Feasibility Study of the Contaminated Groundwater
at the CPS Chemical/Madison Industries Site
Old Bridge Township,
Middlesex County, New Jersey

DRAFT REPORT

June 30, 1989

FIGURE 1-16a. 1988 ZINC CONCENTRATIONS (ppb)

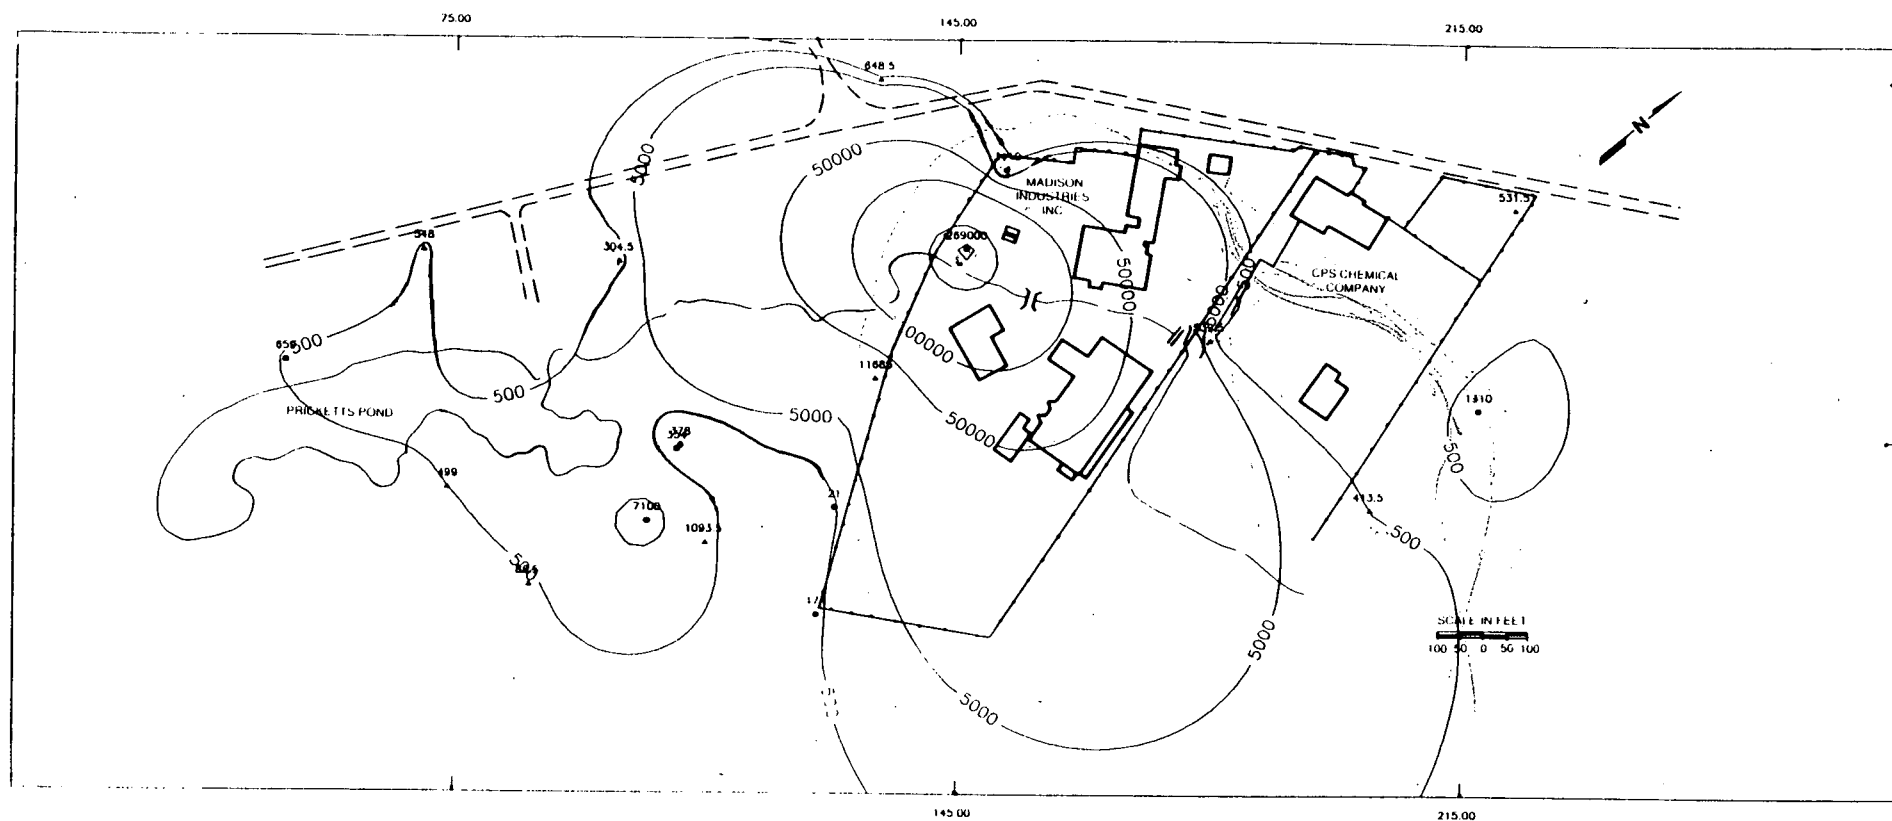
Pond
controlling
plume
should
be
deleted.
delete
